RECEIVED  
 DEC 05 2006  
 RESUBMIT APPROVED  
 BY gpw DATE 12/10/06

PIKE INDUSTRIES  
 VT RTE 8, RURAL MAJOR COLLECTOR  
 READSBORO, VT

BOX CULVERT LAYOUT AND DETAILS - BRIDGE NO. 02  
 Drawing No. C18331-L01-1  
 Quantity: 1 Project No: AC STP ST CULV (4)

**BAFFLE WALL SECTION**

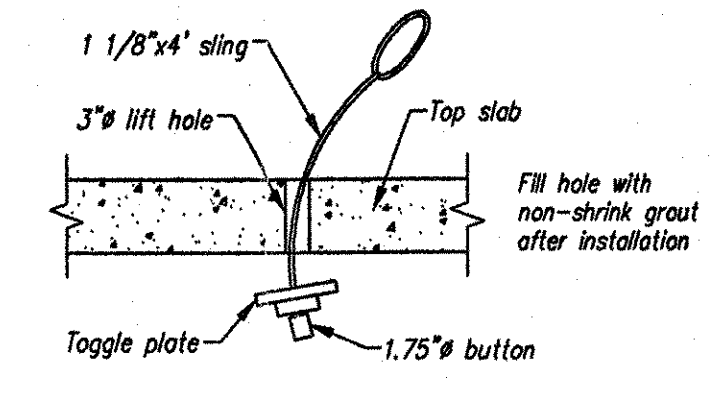
Rev.	Date	DESCRIPTION	By
5			
4			
3			
2			
1	11/21/06	Revised baffle walls to be 12" thick; Changed baffle at outlet to be by others	MS/TK
